HISTORIC AND DESIGN REVIEW COMMISSION

June 7, 2017

HDRC CASE NO: 2017-205
ADDRESS: 531 E HUISACHE AVE
LEGAL DESCRIPTION: NCB 3090 BLK 6 LOT 27
ZONING: MF-33
CITY COUNCIL DIST.: 1
DISTRICT: Monte Vista Historic District
APPLICANT: Andrew Holbrook
TYPE OF WORK: Construction of a 2-story rear accessory structure, hardscape modifications

**EXTERIOR ELEVATIONS -
GARAGE APT.**

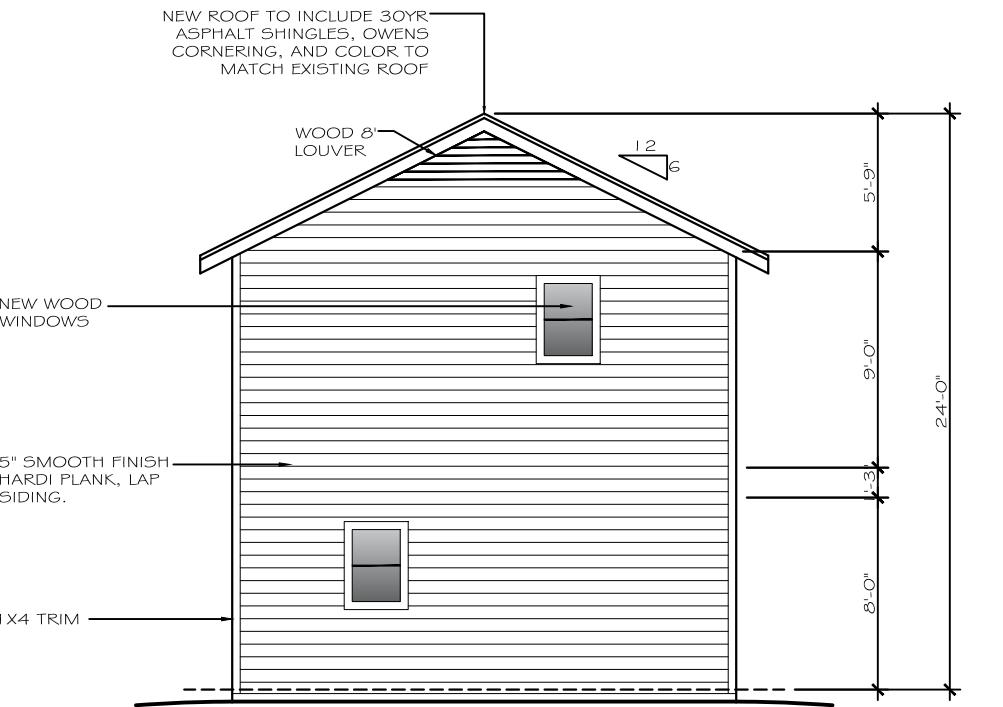
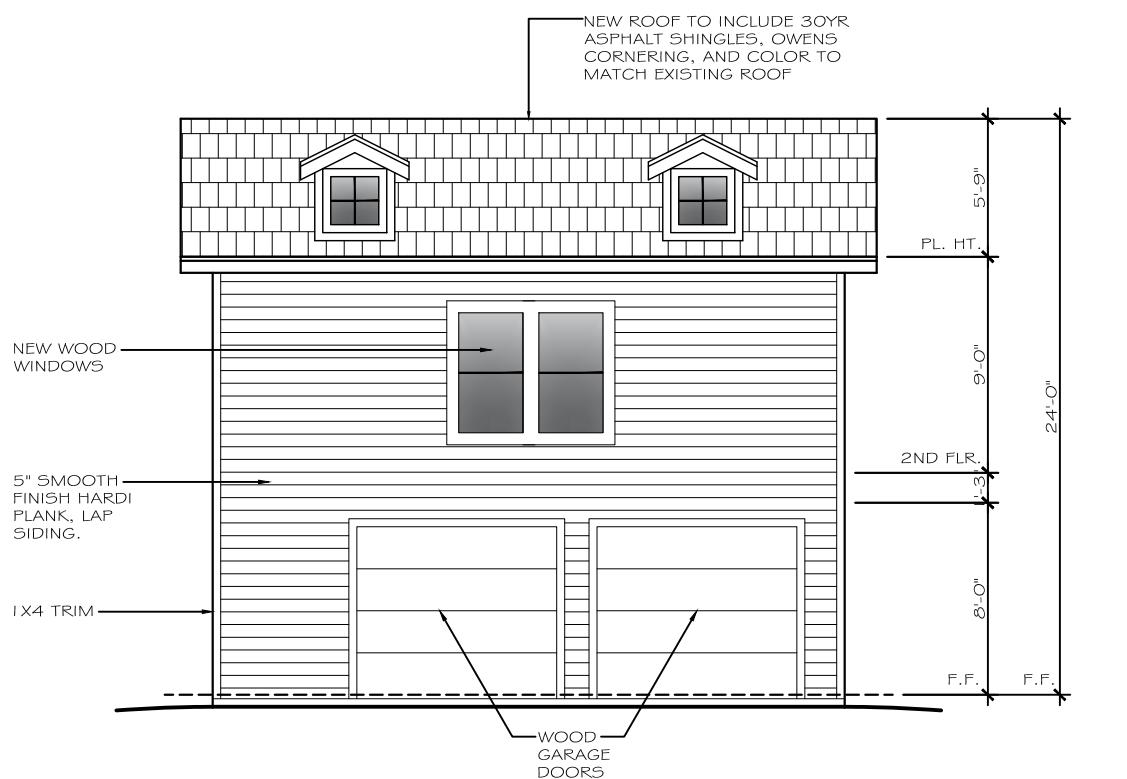
- j. ROOF DETAILS – The applicant has proposed a shed roof with two shed dormers facing the public right-of-way. The guidelines stipulate that architectural details of new construction should keep with the predominant architectural style along the block face or within the district when one exists. Details should also be simple in design and should complement, but not visually compete with, the primary structure or adjacent structures, and details more ornate than those found on the primary structure should be avoided. Staff finds the use of dormers incompatible with the style of the primary structure and inconsistent with the Guidelines.

- a. That the applicant modifies the proposed windows to comply with the OHP Window Guidelines Policy Document.
- b. That the applicant removes the roof dormers.
- c. That the applicant explores ways to salvage and reuse the woodlap siding from the existing accessory structure in the new garage to provide visual interest while ensuring compatibility with the primary structure and the district as a whole
- d. That the applicant installs a door on the ground floor of the structure for accessibility.
- e. That the applicant submit a final landscaping plan indicating all dimensions, locations, and materials of hardscaping or landscaping modifications.

EAST ELEVATION

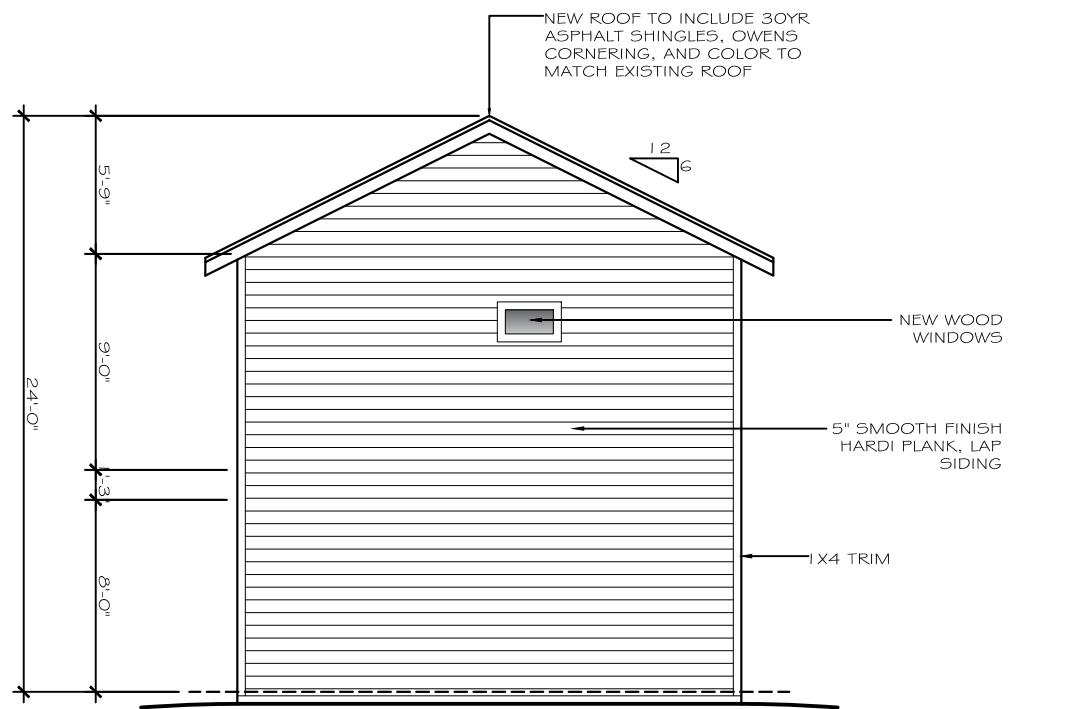
- g. WINDOW OPENINGS – The applicant has proposed to install a small rectangular fixed window on the east elevation measuring approximately 1x2'. According to the OHP Window Policy Document, windows used in new construction should maintain traditional dimensions and profiles found on the primary structure or within the historic district. Staff finds the use of the 1x2' window inconsistent with the Guidelines.

- h. DOOR OPENINGS – The proposed accessory structure does not contain a door for entry into the structure. Currently, the only means of access provided are the proposed garage doors. According to guideline 5.A.iv for New Construction, window and door openings should be similar to those found on historic garages or outbuildings in the district or on the principle historic structure in terms of their spacing and proportions. Staff finds the lack of a door inconsistent with these Guidelines and inconsistent with modern code regulations.
